Re: Planning Commission hearing for PLN2016-00153, APN 047-071-260, Sevilla Avenue, El Granada

Diagram C – Reduce size of 2nd story window

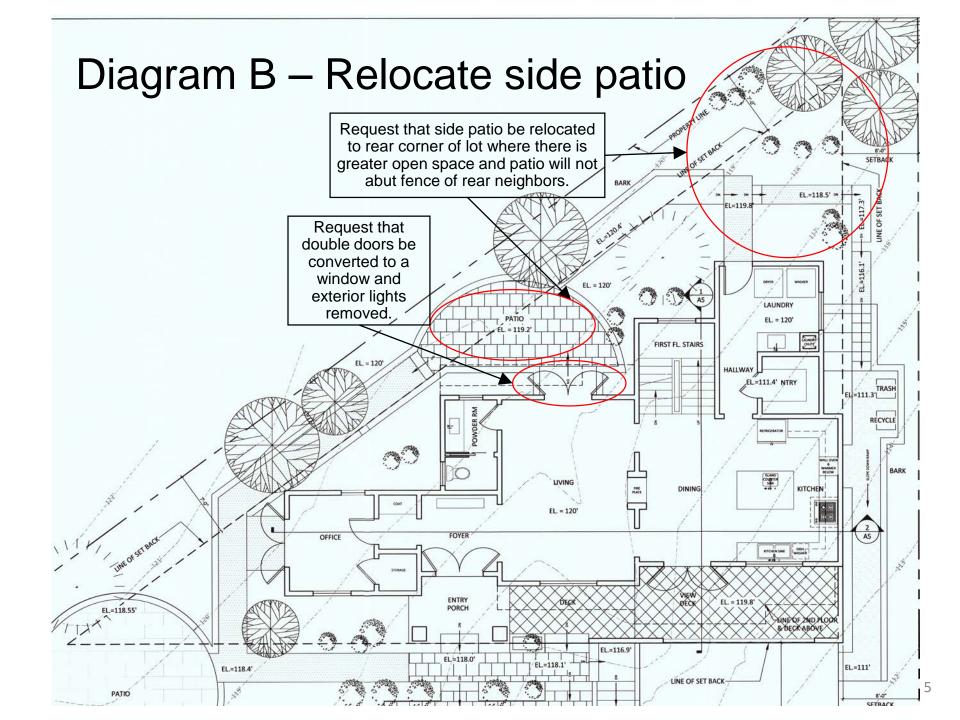
3. Reduce size of second story rear right side window

The designs include a large three-paned window on the rear right-side of the second story (see attached <u>Diagram C</u> on page 6). This window would allow direct sight lines into our house. We request that the size of the window be reduced to match other second story windows to minimize direct views into our house in compliance with the *Design Standards*.
